UN#13-057

**Response to NRC Request for Additional Information  
RAI 339, Questions 03.08.04-33 and -34, Other Seismic Category I Structures,  
Calvert Cliffs Nuclear Power Plant, Unit 3**

**RAI No. 339**

**Changes to CCNPP Unit 3 COLA Associated with the Response to  
RAI 339, Questions 03.08.04-33 and -34,  
Calvert Cliffs Nuclear Power Plant, Unit 3**

**FIGURE 1**  
**CONTOUR PLOTS OF BEARING PRESSURE FOR STATIC LOAD COMBINATIONS**

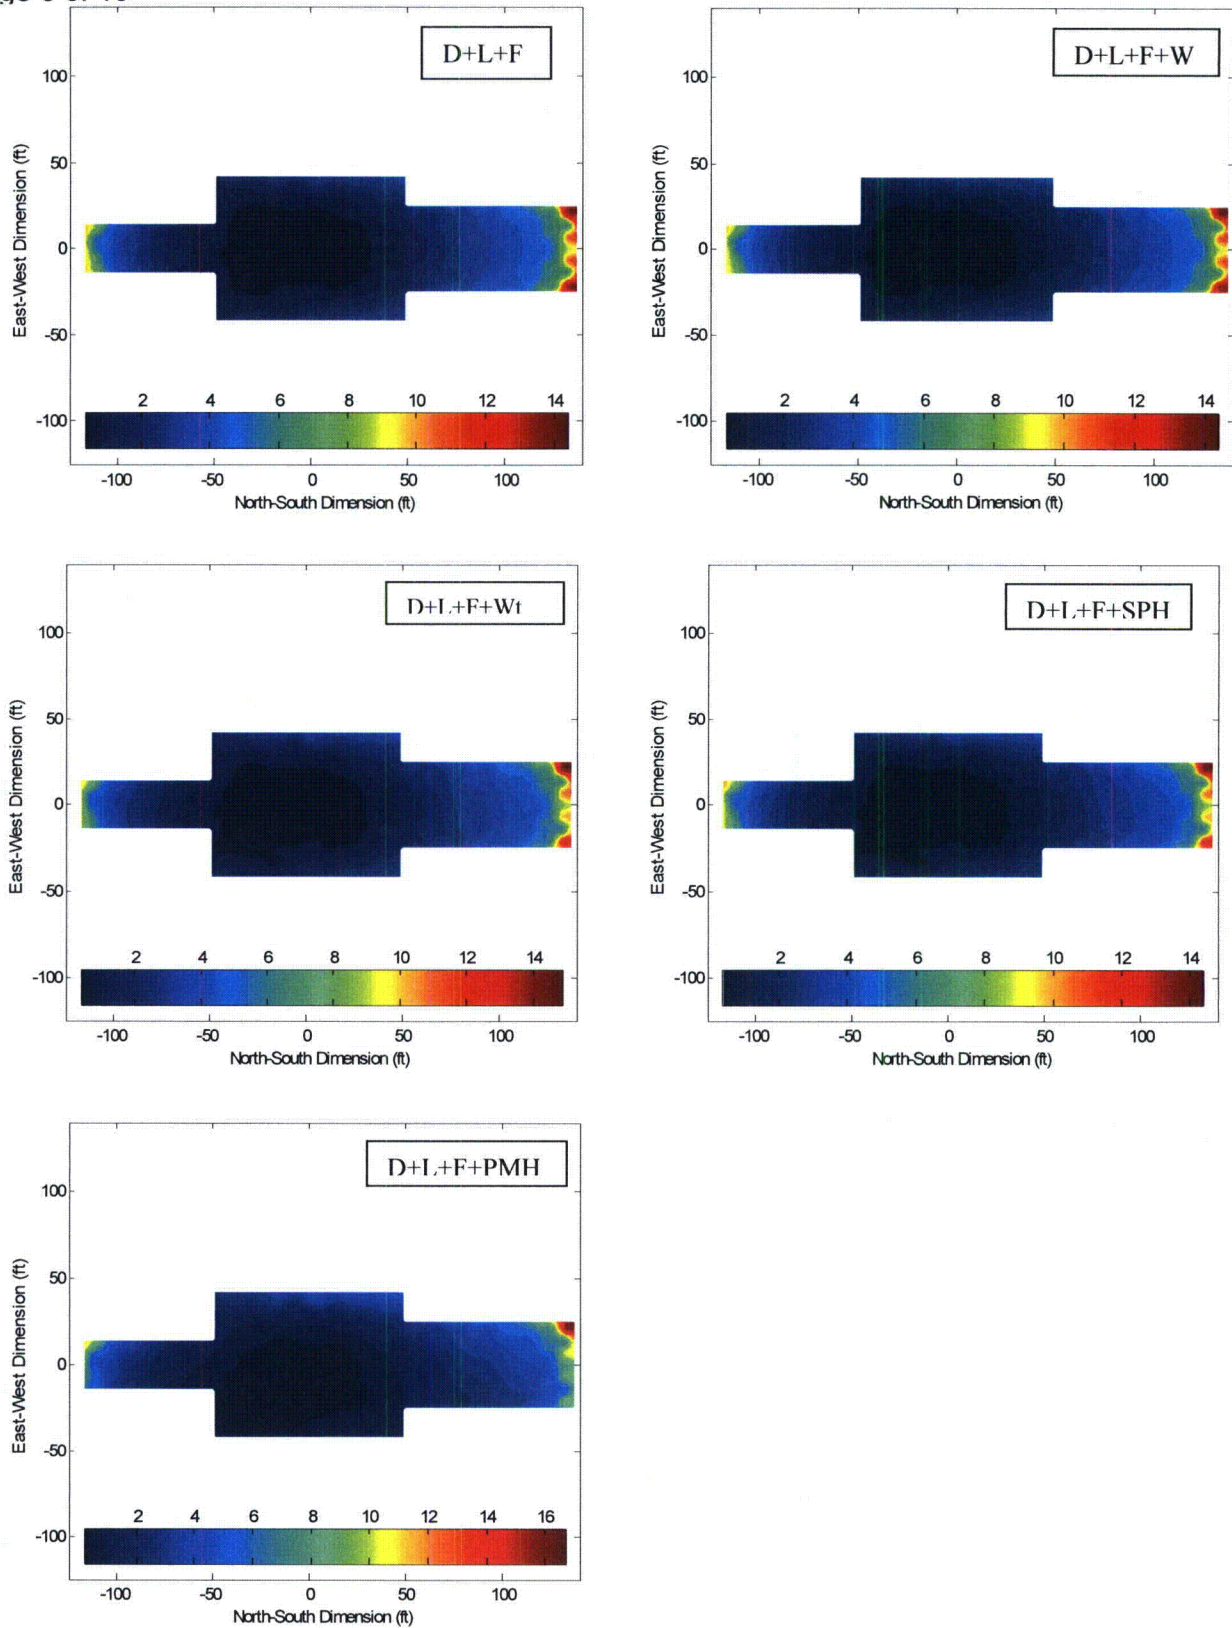
In RAI 301, Question 03.08.04-20, the staff requested that the applicant provide additional information on (1) the exclusion of soil load/lateral earth pressure (H) in the load combinations listed in FSAR Section 3.8.5.3 for bearing pressure evaluation, and (2) the large differences in maximum bearing pressure and bearing capacities between Revision 6 and Revision 7 of the CCNPP Unit 3 FSAR, for the design of the UHS Makeup Water Intake Structure (MWIS).

The staff reviewed the response to RAI 301, Question 03.08.04-20 provided in UniStar Letter UN#11-278 dated November 4, 2011 (ML11314A040). Regarding the bearing pressure calculation, the staff determined that additional information is needed to resolve this RAI item. Since the RAI response indicates that the maximum bearing pressures (static and dynamic) of the CBIS are the maximum of the average pressures under each of the three intake structures (the UHS MWIS, the Forebay and the Circulating Water Makeup Intake Structure), they are not the localized pressures such as the pressures at the toe of the CBIS basemat. The staff requests that the applicant provide the values of the maximum pressures considering all locations of the CBIS basemat design (e.g., maximum pressures that may occur at the toe/edge/corner of the basemat) under worst-case static and dynamic loads. This would represent the localized maximum soil bearing pressure, not the maximum of the average of pressures under each of the three intake structures. Furthermore, explain how these pressures are obtained, e.g., how the soil springs are developed, what the differences are between soil springs for static and dynamic pressures, and how the dynamic pressures from the STAAD Pro FE model analysis compare with the pressures from the SSI analysis, etc. In addition, explain whether the CCNPP Unit 3 bearing capacities provided in Table 3.8-3, as well as those in Table 2.5-65, of the FSAR Revision 7, are the bearing capacities for localized pressure. If they are bearing capacities for localized pressure, explain why the calculated average pressures of the CBIS are compared with the bearing capacities for localized pressure. If they are bearing capacities for average pressure, explain why in Table 2.0-1 of the CCNPP Unit 3 FSAR Revision 7 the CCNPP Unit 3 bearing capacities are compared with the U.S. EPR bearing capacities for localized pressure.

Contour plots of bearing pressure for these load combinations are provided in **Figure 1**. Average bearing pressures across the CBIS basemat and maximum localized pressures for each load combination are provided in **Table 1**.

The contour plots in **Figure 1** indicate that maximum local pressures are concentrated around the Southern edge of the CBIS.

1. Calculation of the resultant foundation load and its corresponding eccentricity that is equivalent to the bearing pressure distribution shown in **Figure 1**.
2. Determination of the reduced area (effective area) due to eccentricity.
3. Computation of the increased average bearing pressure as the ratio of the total vertical load to the reduced area.

**Table 1** shows that the average foundation pressures for the entire CBIS area (not the reduced area) are lower than the static bearing capacity, 11.7 ksf, reported in Table 2.5-67 of Rev. 9. The reduced area or effective area calculated based on the eccentricity is at least 65 percent of the overall area. To be conservative, a reduction of 50% in the area of the CBIS is considered in the calculation of the average bearing pressure. The increased average bearing pressures corresponding to the 50 percent reduction in the area are shown in **Table 1** and these are lower than the bearing capacity.
